Proof of Evidence Addendum

Land off Pump Lane, Rainham

APP/A2280/W/20/3259868 Prepared by Karl Jarvis

Prepared For: Medway Council

JOB TITLE PUMP LANE, LOWER RAINHAM		CLIENT A C GOATHAM	
DRAWING TITLE PEDESTRIAN CROSSING EAST OF BOWATER OPTION 1			
SCALE 1:500@A1	DRAWN BY RM	DATE 22/02/21	DRAWING No 20230-16
			REVISION

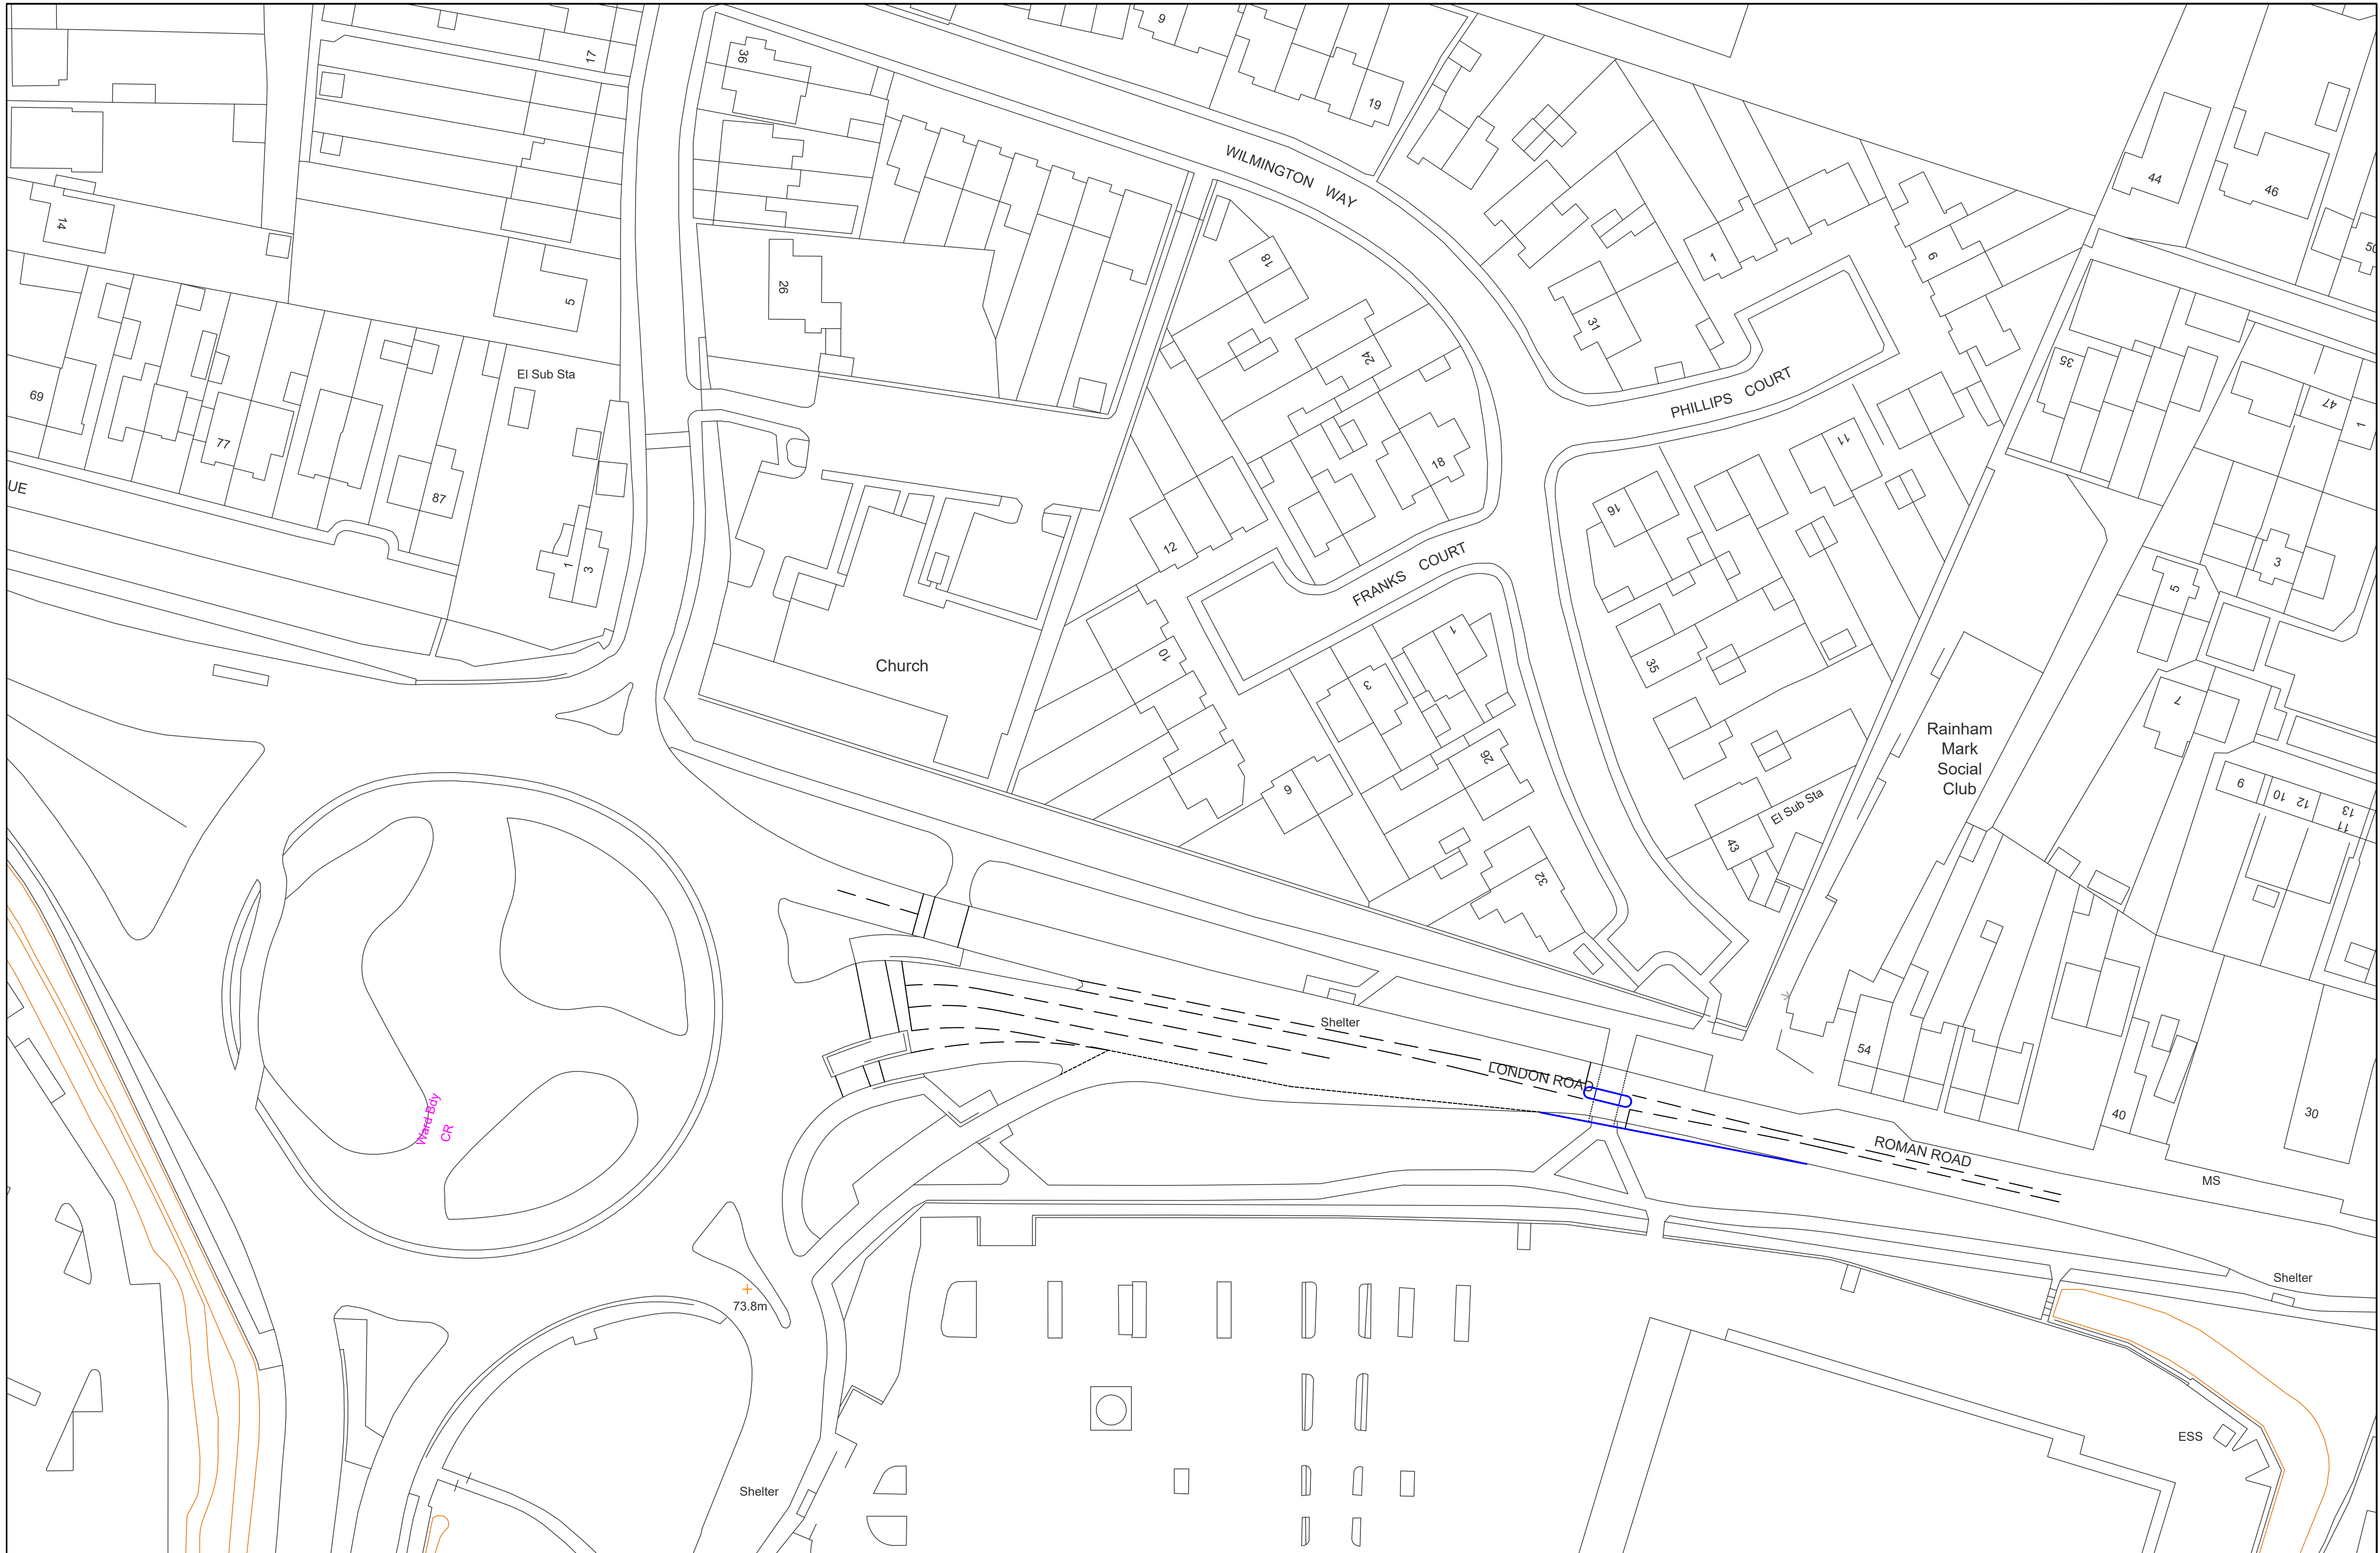
6. Should the operation of the crossing become an issue there are interventions that could be readily implemented to overcome this bottleneck. This arrangement is shown on **DTA Drawing 20230-16**.

- 2.3 ID24 contains two options for a mitigation scheme at the toucan crossing east of Bowaters roundabout, as shown on drawings 20230-16 and 20230-17. DTA will confirm which of the two options they wish to be incorporated into the revised MAM assessment.

JOB TITLE PUMP LANE, LOWER RAINHAM		CLIENT A C GOATHAM	
DRAWING TITLE PEDESTRIAN CROSSING EAST OF BOWATER OPTION 2			
SCALE 1:500@A1	DRAWN BY RM	DATE 22/02/21	DRAWING No 20230-17
			REVISION

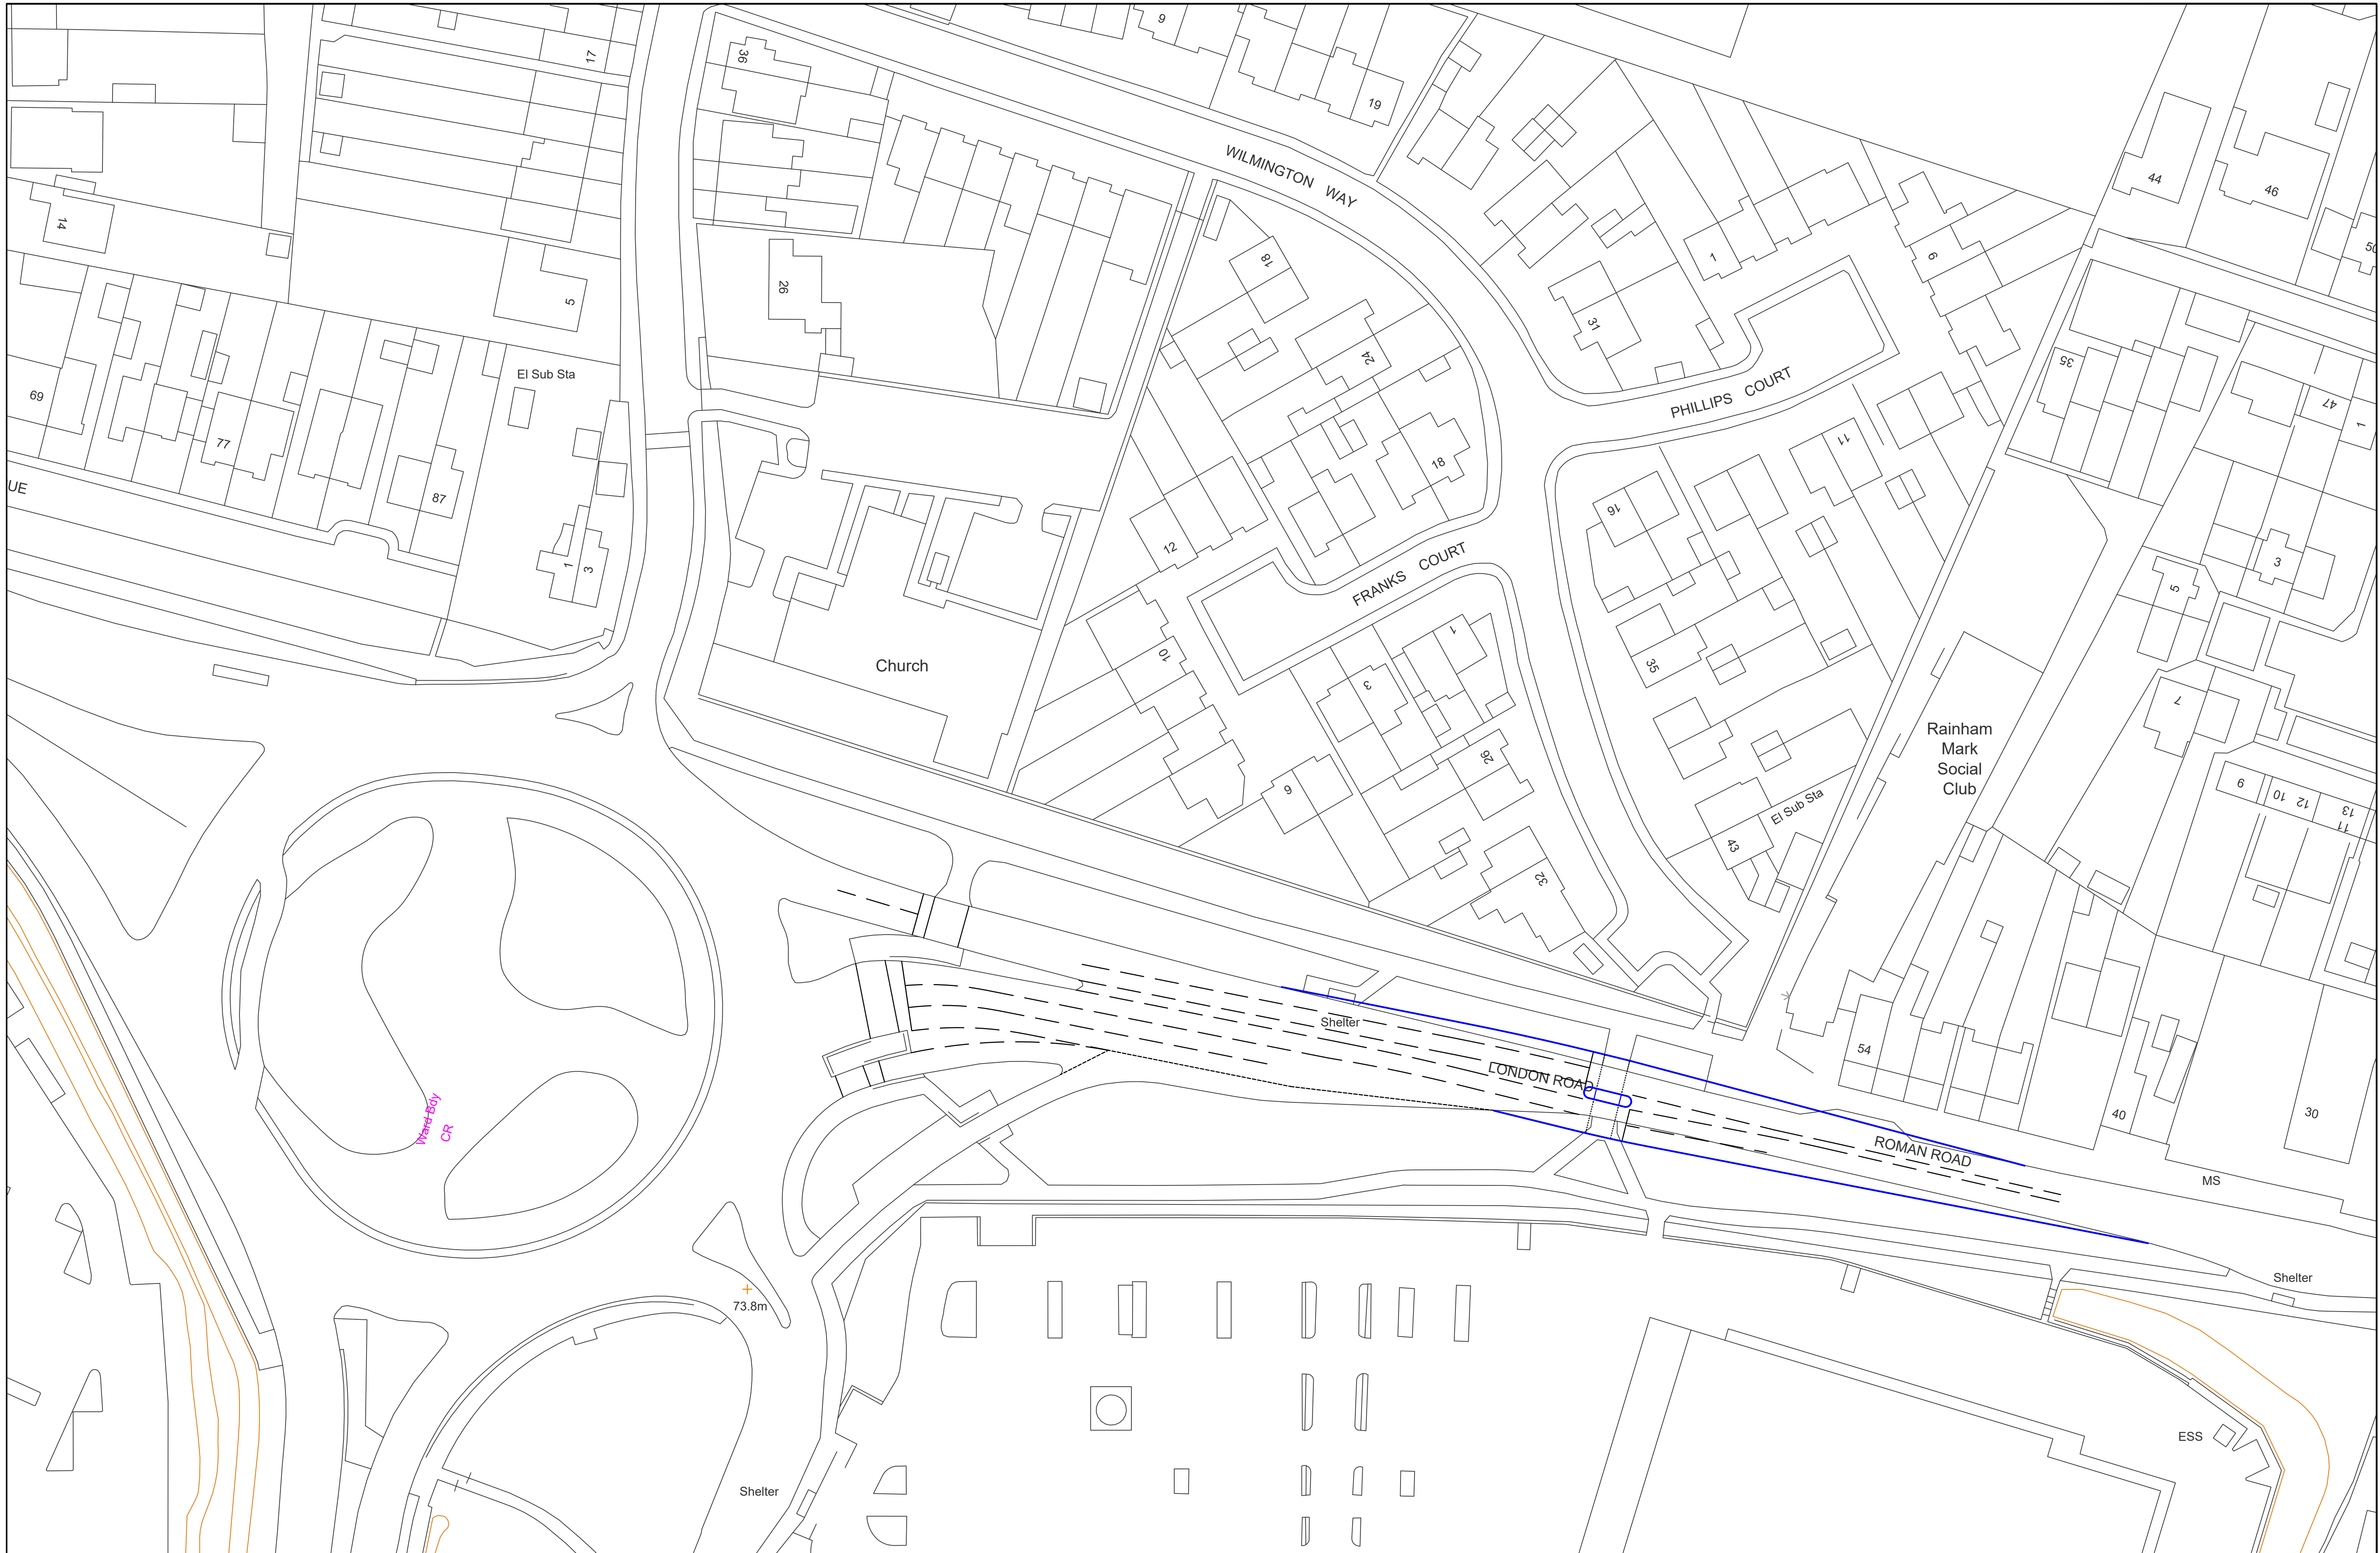
10. A more significant increase in capacity would be achieved by doubling the number of lanes entries and taper these down to the west of the crossing. This arrangement is shown on **DTA Drawing 20230-17**. In broad terms doubling the lanes will double the traffic capacity however the intergreens would increase reducing this gain in addition to which the capacity of the funnel would limit any capacity increase to a 50% increase in traffic demand; equivalent to a further 1,000 vehicles per hour.
